STATUTORY RULES OF NORTHERN IRELAND

Traffic Signs (Amendment) Regulations (Northern Ireland) 2003

Made - - - -	*3rd April 2003*
Coming into operation	*19th May 2003*

544.1A
Traffic calmed area

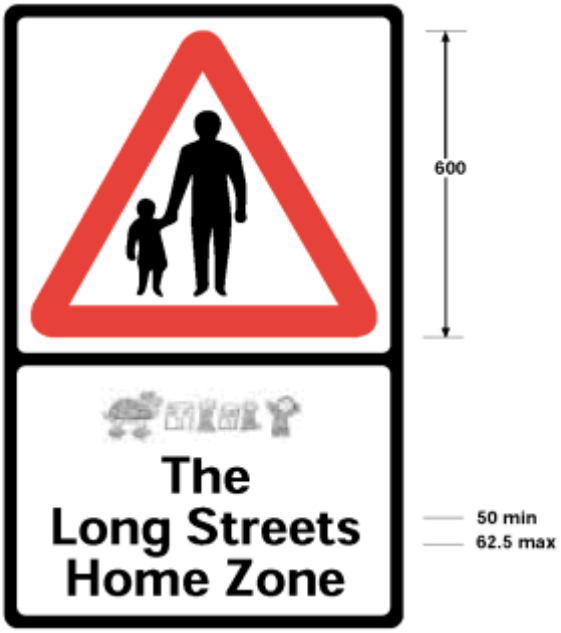
(4) In Schedule 1 (warning signs) after diagram 544.1 there shall be inserted the following diagram and the words specified in and under it –

Item	
1	Regulations: 11(1), 11(4)
2	Diagrams: None
3	Permitted variants: Schedule 16, item 18 The pictogram in the lower portion of the sign may be varied or omitted. The place name may be varied or omitted. A road safety slogan may be added below the place name. The place name and road safety slogan may be in any style of lettering. Any contrasting colours except red may be used for the place name or road safety slogan and the background of that part of the sign. Advertising material or political slogans shall not be included on the sign
4	Illumination requirements: Schedule 17, item 1

784

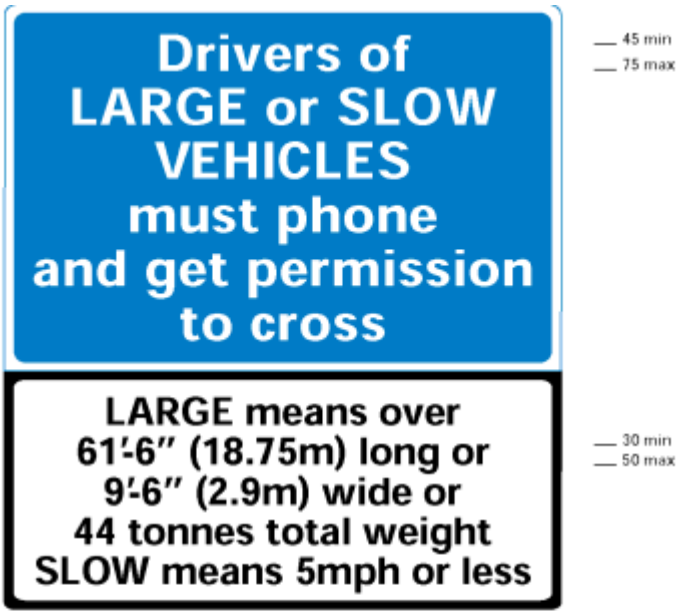
(6) In Schedule 3 (signs for railway and tramway level crossings) for diagram 784 and the words specified in and under it there shall be inserted the following –

Drivers of large or slow vehicles must stop and telephone before using an automatic railway or tramway level crossing

Item	
1	Regulations: 8, 14(1)
2	Diagrams: None
3	Permitted variants: The expression "61'-6" (18.75m)" may be replaced by "55' ", in which case the expression "(2.9m)" shall be deleted and the figure "44" replaced by "38"
4	Illumination requirements: Schedule 17, item 1
